Access Compliance Report

Public Rights-of-Way

Intersection ID: 9578	Main Street: WOODWARD_AV	Cross Street: STATESVILLE_AV	Location: SW
ADA ID: 24E36823D8CC	Ramp Type: Perp	Initial Pass/Fail: Fail	Overall Compliance: No
Severity Score: 22.5			
Codes/Mitigation Info/Possible Solution		Field Measurements/Component Compliance

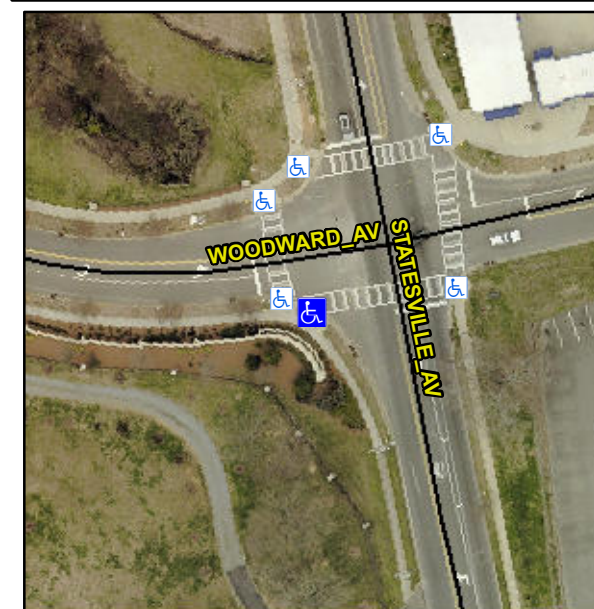
Not Found, R304.5.1, R304.2.2, R304.5.3

Compliance	Description	Data	Compliance	Description	Data
N/A	Ramp Length (in)	69.5	No	Ramp Slope (%)	9.8
No	Ramp Width (in)	42.5	No	Ramp XSlope (%)	2.2
N/A	Flare Type LT	N/A	N/A	Flare Type RT	N/A
N/A	Flare Slope LT (%)	N/A	N/A	Flare Slope RT (%)	N/A
N/A	Flare Traversable LT?	N/A	N/A	Flare Traversable RT?	N/A
N/A	Landing Length (in)	N/A	N/A	DWS Provided?	N/A
N/A	Landing Width (in)	N/A	N/A	DWS Contrast?	N/A
N/A	Landing Slope (%)	N/A	N/A	DWS Length (in)	N/A
N/A	Landing X Slope (%)	N/A	N/A	DWS Full Width?	N/A
N/A	Landing Curb? (Y/N)	N/A	N/A	DWS Offset (in)	N/A
N/A	Shared Landing?	N/A			
N/A	Gutter Ponding?	N/A	N/A	Gutter Slope (%)	N/A
N/A	Gutter Lip Ht (in)	N/A	N/A	Gutter X Slope (%)	N/A
N/A	Painted X Walk1?	No	N/A	Painted X Walk2?	N/A
	X Walk 1 Direction	To E		X Walk 2 Direction	N/A
N/A	X Walk 1 Width (in)	N/A	N/A	X Walk 2 Width (in)	N/A
	X Walk 1 Slope (%)	4.5		X Walk 2 Slope (%)	N/A
	X Walk 1 X Slope (%)	1.2		X Walk 2 X Slope (%)	N/A

Remove & Replace Entire Ramp.
